Village of Arlington Heights  
Plat and Subdivision Committee  
Community Room, 3rd Floor  
Arlington Heights Village Hall  
33 S. Arlington Heights Road  
Arlington Heights, IL 60005  
March 22, 2017  
7:00 PM

- A. Industrial Development - 702-723 W. Algonquin Rd. - T1581  
Preliminary PUD, Plat of Subdivision to Consolidate Lots

VILLAGE OF ARLINGTON HEIGHTS  
**STAFF DEVELOPMENT**  
**COMMITTEE REPORT**

Temp File Number: T1581  
Project Title: 703-723 W Algonquin Ind. Redev.  
Address: 703-723 W. Algonquin Rd.  
PIN: Multiple PIN's

Conceptual Site Plan

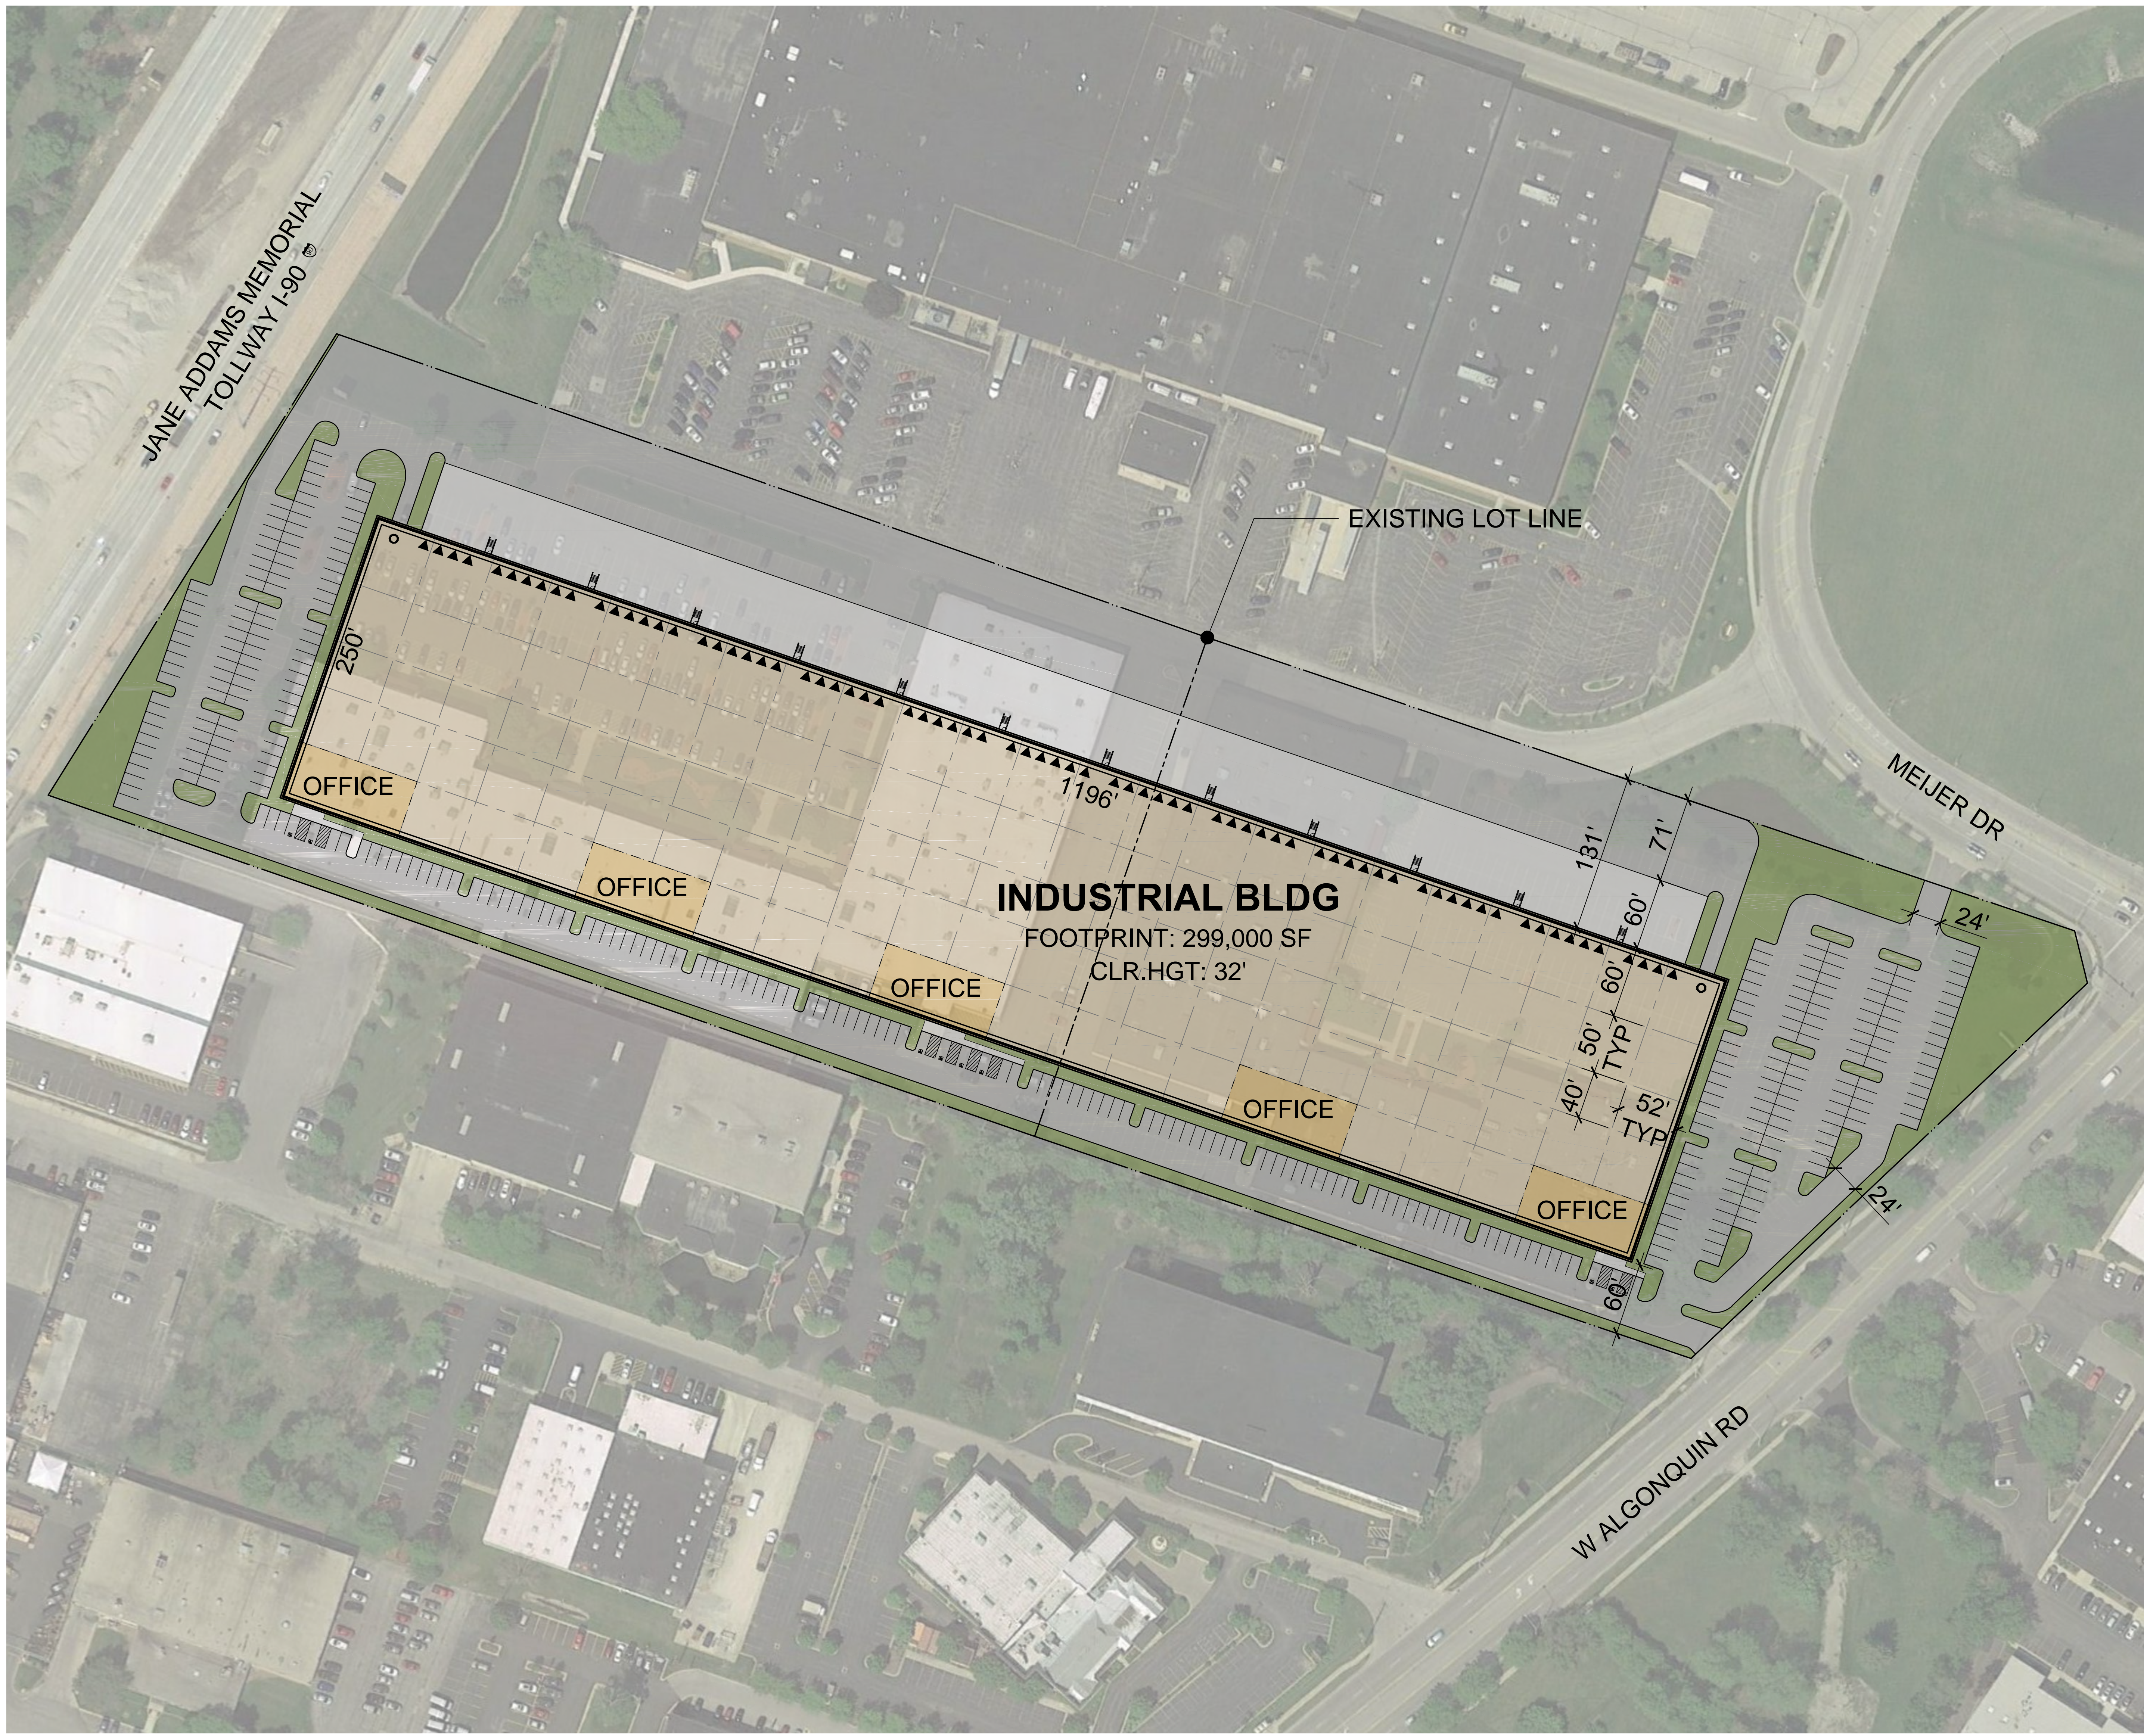
Preliminary analysis shows that the both phases of development will conform to all setback and bulk standards within the M-2 District, with exception to the rear parking row within Phase II which appears to be setback only 5' from the rear property line where all parking and storage must be setback a minimum of 15' from the rear property line. Although there are no height, building coverage, and impervious surface coverage regulations within the M-2 District, the petitioner should provide data on these aspects of the development to allow staff to understand the overall impact of the building on the site.

The applicant should examine the southwestern corner of the site and provide additional green space in this area. Currently, this area is shown as impervious surface and it does not appear that paving will be necessary here to allow for truck movements. Additionally, the proposed development must comply with all Village and MWRD regulations regarding detention, and additional stormwater detention facilities may be needed. Finally, a code compliant photometric plan will be required as part of any formal PUD application, and a Design Commission application will be required for the proposed development.

Both phases of the development conform to parking requirements, however, the petitioner should note that parking requirements for a warehouse facility are based on the number of employees at peak shift, plus the number of vehicles that will be used in the conduct of the premises (i.e. one space per loading bay). Since the development is being constructed without any known tenants and interior buildout plans, the number of employees is unknown, the total square footage of all office spaces is unknown, and the 74 loading bays are only a conceptual design. Therefore, the total amount of code required parking is unknown. The petitioner should be mindful to design the parking to accommodate one parking space for every two employees, plus one parking space per loading bay, plus one parking space per every 300 square feet of office areas in order to conform to code requirements. Given the estimate of 350 employees, 74 loading spaces, and 26,000 square feet of office space, 336 parking spaces would be required and 363 parking spaces have been proposed. Finally, staff notes that Phase I appears to have a handicap parking stall that shares an access aisle with a neighboring handicap stall, which is not allowed by code and should be revised.
